ENVIRONMENTAL GROUP, INC.  
ENGINEERING, ARCHITECTURE AND SURVEYING, PC

**Re: RASCO Materials, LLC – Site Plan Approval  
Response to Comments**

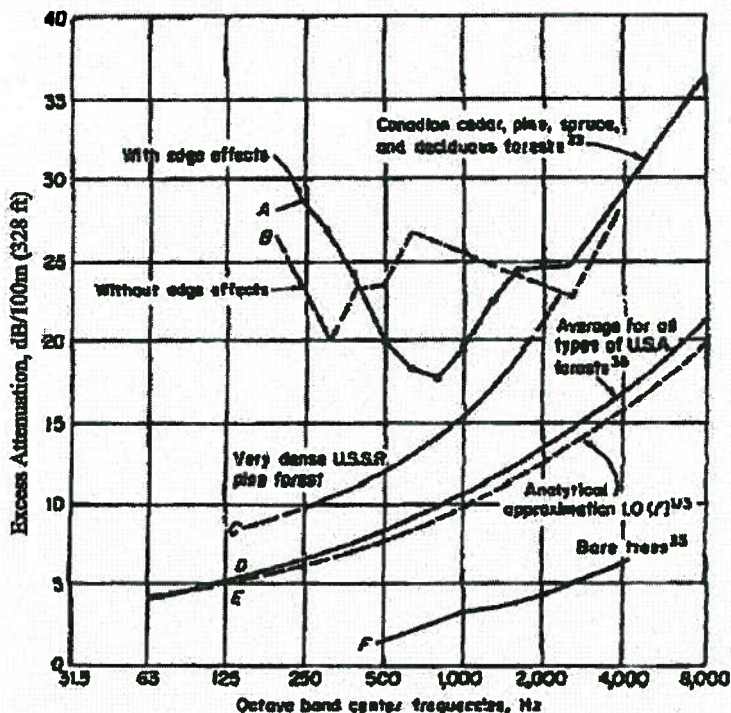
*For several receptors, the requirements of 6NYCRR Part 360-1.14(p) are satisfied because "15 dBA of foliage attenuation" is assumed. The NYSDEC permit limits the operation of the site from March 1 through December 1, provided that the ambient temperature is 45 degrees Fahrenheit or warmer. As such, the site is permitted to operate for 4-5 months in the leaf-off season. Therefore, the Applicant should verify that the assumed foliage is evergreen. It is noted that a worse case scenario noise analysis is typically in the winter months when most trees/foliage lose their leaves and the ground is frozen so there is minimal ground absorption.*

Taking the issue of ground absorption first, it should be noted that the noise projections in Spectra's model were run without the benefit of atmospheric absorption, which attenuates noise by 1 to 2 decibels at distances of up to 1,000 feet. As a result, the noise projections in the model are conservatively high and overstate actual projections by at least 1 to 2 decibels. It must also be noted that, while running between March 1 and December 1, RASCO will never be operating in a frozen ground condition.

The tree cover in the vicinity of the Mid-Hudson Recycling Facility is characterized by a mixture of deciduous and coniferous trees with shrubs and herbaceous ground cover. From the RASCO site to the surrounding receptors, the thickness of intervening vegetation ranges from 500 feet to 2,300 feet. This significant vegetative buffer in all directions will greatly reduce noise propagation from the site when the facility is operational.

This conclusion is supported in literature. Specific reference was taken from Noise Vibration and Control Engineering by Leo Beranek, author of many sound propagation publications, in which he describes noise attenuation due to intervening vegetation. The following chart, taken from Beranek's book shows measured excess attenuation for sound propagation through trees. In this chart, one can see that for thick forests attenuation due to trees is on the order of 10 to 25 decibels per 100 m (328 feet). For forests that are thinner, the vegetative attenuation is on the order of 5 to 12 decibels for every 328 feet. Using these numbers, the attenuation due to vegetation at this site, with forest thicknesses ranging from 500 feet to 2,300 feet, will range from 15 to 30 decibels (depending on direction). In our analysis, Spectra employed the lowest of all estimates in the credit taken for attenuation due to vegetation. Spectra's incorporation of 15 decibels is conservative for the vegetative thicknesses surrounding the site, and is only one-half that cited in the literature as the maximum attenuation due to intervening vegetation.

The model as constructed incorporates a leaf-off conditions (early November to late April in this part of the Hudson Valley). The issue of leaf-off conditions is clearly defined in the literature. As can be seen in the table below, bare trees yield excess attenuation on the order of 0 to 6 decibels per every 328 feet of vegetation, depending on octave band frequency. In the range of sensitivity to the human ear (500 to 8,000 Hz), attenuation due to bare trees is on the order of 2 to 6 decibels for every 328 feet of trees. In the setting at hand, this equates to attenuation from bare trees on the order of 7 to 36 decibels, depending on direction and frequency.
